ECE/TRANS/WP.29/GRE/2006/47/Rev.1
18 January 2008

Proposal for draft amendments (Revision 2) to Regulation No. 113
(Headlamps emitting a symmetrical passing beam)

Submitted by the expert from the International Motorcycle Manufacturers Association
(IMMA) */

Figure 12: Class E in respect of the passing beam and driving beam.

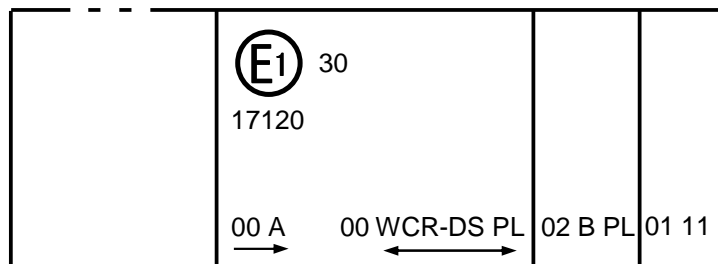
Figure 11: Class E in respect of the passing beam only.
